To: INCITS T10 Committee
From: Susan Gray, Quantum
Date: January 21, 2004
Document Number: T10/04-014r2
Subject: ADT SCSI Application Diagrams

2 Discussion

This proposal applies to ADT Revision 9.

Figure X SCSI Command with no data phase

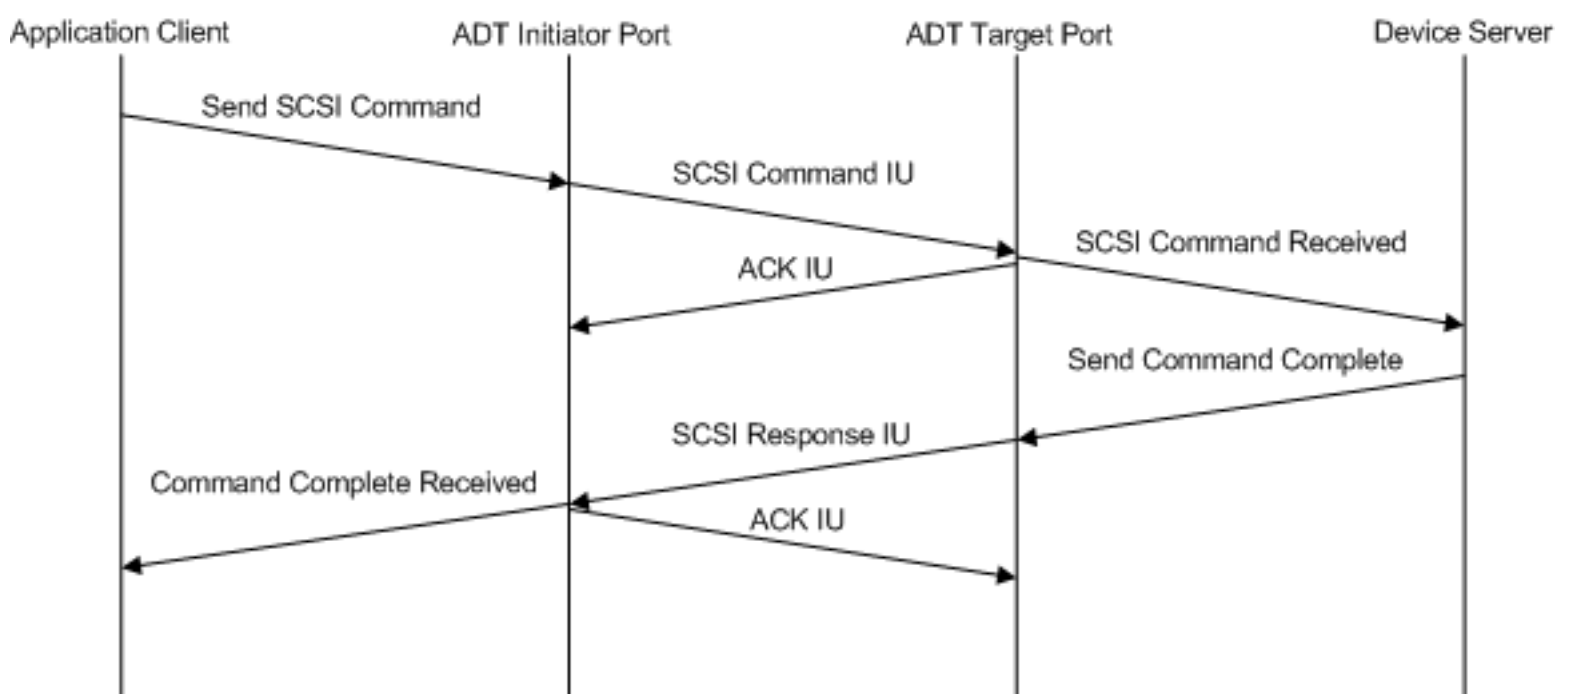
A.2 SCSI command with no data phase

Figure x shows how SCSI transport protocol services may be used to process a SCSI command that has no data phase.
